INDESIT company

BCB333AAVEIS/HA

F048753

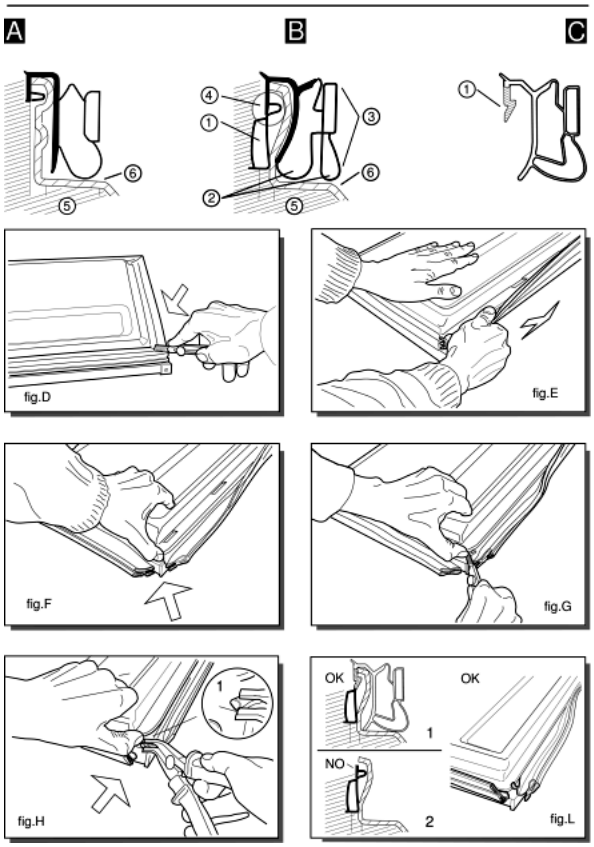
0522067: SEALS FOR DOORS FOAMED AS ONE PIECE

Various types of gaskets with different profile, as shown in figures (A) and (B), are used to fix the door (fig. A-5; B-5) and the inner door (fig. A-6; B-6) on the block foamed doors of combined freezers and refrigerators.
---Ilpea profile 245; 179; 412 (fig.A)
---Ilpea profile 287 (fig.B)
When replacing gaskets with profiles 245; 179; 412 these are fixed with screws (2 per corner) to the door.
Gaskets with profile 287 can not be used as spare parts but are designed to house the Ilpea type 900 gaskets (see figure C).
When replacing the gasket (287), once it is removed you will find a pocket (fig. B-1) between the door and inner door.
The rigid tooth (fig.C-1) of the gasket (900) is inserted inside between the pocket and the inner door, doing away with the need for screws.
Gasket with profile 287 is easy to identify since it has an exterior double edge (fig.B-2) which acts as a cushion when the door is closed.

To replace this gasket, follow these steps:
---Dismount the door and cut the four corners of the gasket along the joint (fig.D);
---lift the gasket and pull it carefully along its full length without tearing it (fig.E).
The purpose here is to detach the inner door slightly from the foam along the exterior edge for a depth equal to that of the gasket (fig.B-3);
---lift the corner of the inner door slightly, prising it up with your thumb (fig.F). Do not use a tool which might break the inner door;
---continue cutting the gasket inside the inner door for about 6 mm (fig.G);
---push in the tip of the pliers (type USAG N131) and pull outwards until you see the top edge of the pocket (fig. B-4) which is empty (fig.H-1);
---if you carry out this operation correctly (fig.L) you will be able to pull off the top edge of the pocket for the full length of the door.
If the gasket tears before the top edge (fig. L-2) you should repeat this operation from the other corner of the door.

---once the gasket (287), has been removed the space above the pocket (fig. L-1) can house the rigid tooth (fig. C-1) of the gasket 900.
When you fit this gasket ensure that it lies flush against the edge for the full length of the door.
If the rigid tooth is difficult to fit, eliminate any residues of foam between the door and the inner door in the gasket area.
fig.5131549A
